No.	Company & Group	Page & Paragraph	Comment	Rationale for Comment	Recommendation	Disposition
001	Avidyne Corporation	General	The attempts made in this AC to reduce the difficulty of transitioning from DO-178B to DO-178C to the minimum necessary to assure safety is much appreciated. In particular, focusing on specific changes made to system software and recommending the use of DO-178C only with regard to those changes will encourage its use rather than encouraging applicants to go to great lengths to avoid it. Continued recognition of DO-178B with appropriate caveats is also a major positive.		None	No response required.
002	Honeywell ODA	Overall	This transition to 178C described in this AC takes a different approach in some respects as compared to Order 8110.49 Chg 1 Chapter 10 regarding the transition to 178B. For example, the Order provides guidance for changed software vs. unchanged but affected software vs. unchanged/unaffected software.	Possible conflict across FAA policy documents.	Provide industry with insight into the changes to be made to Order 8110.49 Chg 1 for consistency with this AC.	Order 8110.49 chapter 10 will become obsolete after AC 20-115C is published. Our appro

Original Proposed Text	Paragraph 9.b. and Figure 1	<p>b. For a project involving legacy system software, follow the procedures in this paragraph. Figure 1 presents a flow chart of the process for use of legacy system software.</p>

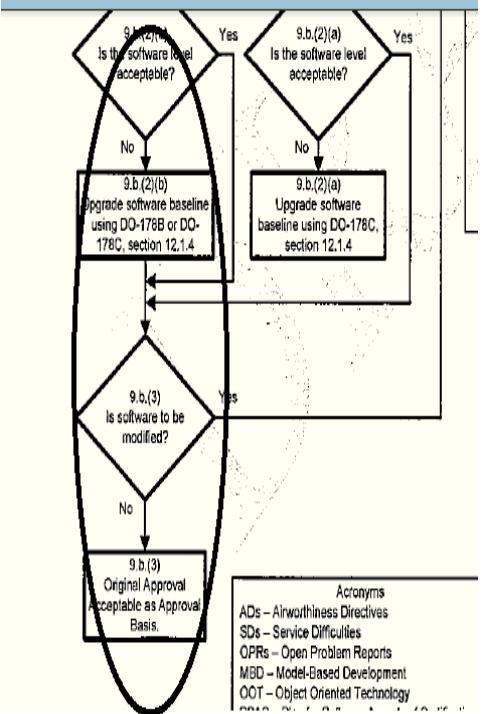
135	Snecma/Safran	Page 5 Figure 1	When software is developed using DO-178 or DO-178A and software level is not acceptable, if the software is to be modified, the end of the flow chart seems to be not consistent.	If software level is not acceptable, the software baseline is to be upgraded using DO-178C section 12.1.4:  But software is changed as 9.b.(5) using the same DO-178 version with an unacceptable level.	If software is to be modified and software level not acceptable, the software should be changed as 9.b.(6) using DO-178C, section 12.1.4.  In 9.b.(5)(b), page 7, a comment should be added: “when 9.b.(2)(a) is applied, the original software plans cannot	Partially accepted. Paragraph 9.b.(5)(b) (now 9.b.(7)(b)) has been rewritten to accommodate changes to the software plans resulting from 9.b.(2).

No.	Company & Group	Page & Paragraph	Comment	Rationale for Comment	Recommendation	Disposition
					still be used.”	
136	Snecma/Safran	Page 5 Figure 1	When software is not to be modified, but software baseline is upgraded due to an unacceptable level, is the original approval sufficient?	The modified data of software baseline (due to upgrade) should be submitted to approval, in the way to verify that the upgraded baseline complies with the software level.	A comment in 9.b.(3) should state that in case of upgraded software baseline (without change of the Executable Object Code), the upgraded data shall be submitted to an incremental approval.	Accepted. Changed 9.b.(3) box to reflect original approval with or without baseline upgrade.
137	L-3 Communications	Page 5, Figure 1.	The box containing “9.b.(2)(a) Upgrade software baseline using DO-178C, section 12.1.4” is missing a continuation arrow.	Flow chart does not support the text of section 9.b.	Insert a continuation arrow from the box containing “9.b.(2)(a) Upgrade software baseline using DO-178C, section 12.1.4” to the 9.b.(3) decision.	Accepted.

138	Eurocopter	Page 5 (Fig. 1)	Box 9.b.(2)(a) is a final state, which does not open the possibility to perform a software change.	Inconsistency in the flow chart.	Box 9.b.(2)(a) should have an output arrow leading to decision box “9.b.(3) Is software to be modified.”.	Accepted.
139	Sikorsky Aircraft	Pg5, fig 1	Box 9.b.(2)(a) missing an output		Add arrow	Accepted.

No.	Company & Group	Page & Paragraph	Comment	Rationale for Comment	Recommendation	Disposition
140	Boeing	Page 5 Figure 1. Legacy System Software Process Flow Chart <u>Box</u> 9.b.(2)(a) [on the left side of the figure]	We recommend adding one simple connector from that box to diamond “9.b.(3) – Is software to be modified?”	This legacy software can be modified, just like DO-178B software can be modified. This connector will complete the flow of upgrading the baseline of legacy DO-178/DO-178A software.	Add a simple connector from the proposed box that states: <i>“9.b.(2)(a) Upgrade software baseline using DO-178C, section 12.1.4.”</i>	Accepted.
141	Pratt & Whitney Aircraft	See text below Figure 1	See diagram below	See text below If an existing 178A project were to add a target code loader tool, then by this AC’s change analysis, one would be required to do all software updates to 178C... which we don’t think that this was what was meant... If you use MBD, OO or Formal methods in the change – then yes, one would expect to use 178C for the change... but introducing a new tool – that one would probably tool qual anyway, should not drive the software change basis up to 178C	See text below Amend the figure to permit tool additions to an existing product without bring the entire application up to DO-178C.	Accepted. The flow chart and respective paragraphs have been revised. The flow chart now refers to paragraph 10 (Tool Qualification) for all tools (new/changes) for process to follow. While we revised the process so as not to require DO-178/DO-178A software upgrade to DO-178C, a new tool would require DO-178C/DO-330 qualification.

No.	Company & Group	Page & Paragraph	Comment	Rationale for Comment	Recommendation	Disposition
142	Pratt & Whitney Aircraft	Figure 1	<p>Flow path for original & upgraded approval conflict</p>  <pre> graph TD D1{9.b.(2)(a) Is the software level acceptable?} D2{9.b.(2)(a) Is the software level acceptable?} D3{9.b.(3) Is software to be modified?} B1[9.b.(2)(b) Upgrade software baseline using DO-178B or DO-178C, section 12.1.4] B2[9.b.(2)(a) Upgrade software baseline using DO-178C, section 12.1.4] B3[9.b.(3) Original Approval Acceptable as Approval Basis] D1 -- No --> B1 D1 -- Yes --> D3 D2 -- No --> B2 D2 -- Yes --> D3 B1 --> D3 B2 --> D3 D3 -- No --> B3 D3 -- Yes --> B1 D3 -- Yes --> B2 </pre> <p>Acronyms ADs – Airworthiness Directives SDs – Service Difficulties OPRs – Open Problem Reports MBD – Model-Based Development OOT – Object Oriented Technology</p>	The flow chart shows a conflicted path to both upgrade the baseline or original approval,	Note the path in Figure 1 that has the circled path... when you determine that you must upgrade your baseline to B or C – then if you’re NOT modifying the software, then “original approval accepted as approval basis” should really say “original or identified upgraded approval accepted as approval basis”	Accepted. Modified flow chart and paragraph 9.b.(3) text accordingly.

143	Eurocopter	Page 5 (Fig. 1)	<p>Decision 9.b.(3) "Is software to be modified?" leads, if no software change is required, to a box "Original Approval Acceptable as Approval Basis".</p> <p>However, one way of reaching this decision is through case 9.b.(2).(b) (upgrade of the DO-178B or DO-178C baseline, if the level is not sufficient for the new installation).</p>	Inconsistency in the flow chart.	<ul style="list-style-type: none"> - Box "9.b.(3) Original Approval Acceptable as Approval Basis" should be the result of decisions "yes" in decision boxes "9.b.(2)(a)" and "9.b.(2)(b)", - This box should also have an output arrow leading to decision box "9.b.(3) Is software to be modified?". 	<ul style="list-style-type: none"> - Partially accepted. Changed 9.b.(3) box to reflect original approval with or without baseline upgrade. - Accepted.

No.	Company & Group	Page & Paragraph	Comment	Rationale for Comment	Recommendation	Disposition
144	THALES Avionics	Figure 1	Inconsistency	There is an inconsistency when a DO178B SW needs to be upgraded to have an acceptable level (9.b.(2).(b)) because when the software is not modified the conclusion is that the original approval is acceptable as approval basis.	Modify figure 1 to solve inconsistency	Accepted. Changed 9.b.(3) box to reflect original approval with or without baseline upgrade.
145	Honeywell ODA	Page 5, Figure 1	This figure has two decision blocks related to para. 9.b.(5)(c). The first decision block can be stated more simply.	Text can be simplified.	1) Change the decision block text to: "Is legacy software developed to DO-178B?" 2) Swap the "Yes" and "No" outputs	Not accepted. Comment not applicable due to revised flow chart.
146	Honeywell ODA	Page 5, Figure 1	This figure has two decision blocks related to para. 9.b.(5)(c). The second decision block uses the 178B terminology for tools and is inconsistent with the text in para. 9.b.(5)(c).	Text is inconsistent.	Change the decision block text to: "Are there new software tools?"	Partially accepted. The flow chart has been revised and recommendation incorporated.

147	Elbit Systems Ltd.	Page 5 Figure 1	Removal of DO-178 & DO-178A related software question	The DO-178 & DO-178A previous developed SW is not relevant here, It can be removed.	this question should be removed from the Figure 1 - Legacy System Software Process Flow Chart	Not accepted. Comment not applicable due to revised flow chart.
148	Randall Fulton	Page 5- Figure 1	Box in lower right hand corner (9.b.(6) Change software using DO-178C, Section 12.1.4, and applicable supplements)	"Change software" could be interpreted as only doing source code changes with DO-178C, when this really means requirements, design, code, verification, SQA, SCM, etc.	Suggest replacing "Change software" with more generic terms such as "Perform activities."	Accepted. Modified in accordance with another recommendation "Change software and associated life cycle data..."
149	EASA	§9.b - Figure1	It is unclear why the activities "Correct product and process deficiencies" as well as "Upgrade software baseline..." are not linked/ followed by the "Change impact analysis" and the following activities on the right path of the figure.	Any change from legacy software should lead to identifying the need to apply DO-178C and its supplements, even for instance to "Correct product and process deficiencies".	Could you please consider the need to link any changes to the Change Impact Analysis and the subsequent evaluations?	Paragraph 9.b.(1) is intended for legacy software that has had issues throughout its life cycle. Problematic software is an indication of processes that are deficient. These processes, as well as the software produced by them, need to be corrected

152	TCCA	Page 5 Figure 1	Box 9.b.(5)(c) Is legacy sw developed to 178 or 178 A? should be removed. The question below needs to be expanded to DO-178 B if criteria 1 or 2 of DO-178 C to new tools apply.	DO-178B new tools that are not Criteria 3 tools need to be qualified by using DO-178C and DO-330.	Delete the top-level box 9.b.(5)(c) and expand the question to add a condition of having under DO-178 B new tools that would belong to criteria 1 or criteria 2 under DO-178 C.	Not accepted. If an applicant is modifying legacy DO-178B software, they may continue to use their DO-178B tool qualification processes. If they are introducing a new tool while modifying DO-178/DO-178A software, they would need to qualify the new tool using DO-178C/DO-330.
153	Eurocopter	Page 5 (Fig. 1)	The flow chart listed in Figure 1 seems to have a numbering system applied to the boxes and decision diamonds that are actually references to sub-section paragraphs of Chapter 9. Having the sub-section numbers at the top of the boxes may be misleading, especially when the same number is attributed to several boxes.	Information is not presented in a clear, concise, manner. When attempting to assess the re-use of Legacy System Software the applicant should not be left with questions as to how to proceed with a project application. The flow chart should be self-understandable and only refer to the text for further details.	The sub-section numbers should not be at the top of the boxes, but listed at the bottom, for reference to additional information in the text of paragraph 9.	Accepted. The subparagraph numbers have been relocated to the bottom of the boxes. Additionally, paragraph 9.b states to follow the procedures in paragraph 9.b, and to use the flow chart along with the text. This means that the reader should not rely on the flow chart alone.

156	Boeing	Page 5 Figure 1. Legacy System Software Process Flow Chart Box 9.b.(5) [at the lower-right of the	We recommend revising this text to read as follows: <i>“9.b.(5): “Change software <u>and associated or applicable lifecycle data</u> using the same DO-178 version as the original approval.”</i>	The DO-178 standards dictate the control over lifecycle data, the same as they dictate control over the software.	Revise text per our recommendation,	Accepted.

No.	Company & Group	Page & Paragraph	Comment	Rationale for Comment	Recommendation	Disposition
		figure]				
157	Boeing	Page 5 Figure 1. Legacy System Software Process Flow Chart Top Diamond 9.b.(5)(c) [on the right-hand side of the figure]	We recommend revising the text to read as follows: <i>“9.b.(5)(c) Is legacy software developed to DO-178 or DO-178A <u>or DO-178B?</u>”</i>	Working the flowchart backwards, if Parameter Data Items are added to a (current) AC 120-76B product, for example, those elements of the product would need to take into account DO-178C. This may possibly be taken care of, however, by the top Diamond's 9.b.(5)(c) [that is – the 178/178A diamond] "No" flow to Diamond's 9.b.(5)(d) "Yes" flow to Box 9.b.(6), because that flow accounts for Parameter Data Items being introduced as part of the change. Please clarify.	Revise / clarify text per our recommendation,	Not accepted. Not sure of question asked in rationale, but the flow chart has been modified such that decision diamond that the comment refers to has been removed. We hope this change helps to resolve your concerns.

158	Boeing	Page 5 Figure 1. Legacy System Software Process Flow Chart Box 9.b.(6) [at the lower-right	We recommend revising the text to read as follows: <i>“9.b.(6) Change software <u>and associated or applicable lifecycle data</u> using DO-178C, Section 12.1.4 and applicable supplements.”</i>	The DO-178 standards dictate the control over lifecycle data, the same as they dictate control over the software.	Revise text per our recommendation,	Accepted.

160	FAAC	5, Figure 1	In general, the flow presented here appears to be straightforward. However, one can postulate various scenarios not well represented. For example, what precludes the imposition of additional issue papers that modify this flow, especially for legacy developments for which the OO or MBD papers deviate from the new guidance in DO-	Presenting a flow is good and helpful. It should, however, come with a caveat that specific situations may dictate deviation from this flow. Legacy software reuse or upgrades should always be coordinated with the FAA in advance.	As noted.	Accepted. Added the following sentences to 9.b.: “Although these procedures will apply to the majority of projects, there may be situations that do not follow this flow. You should coordinate these situations with the certification office.

No.	Company & Group	Page & Paragraph	Comment	Rationale for Comment	Recommendation	Disposition
			332 or DO-331?			
	Final Text	Paragraph 9.b and Figure 1	<p>b. For a project involving legacy system software, follow the procedures in this paragraph. Figure 1 presents a flow chart of the process for use of legacy system software. <u>Figure 1 presents a flow chart for using legacy system software. Use the flow chart while following the procedures in this paragraph if you are modifying or re-using legacy system software. Although these procedures will apply to the majority of projects, there may be situations that require deviation from this flow. You should coordinate these situations with the certification office.</u></p>
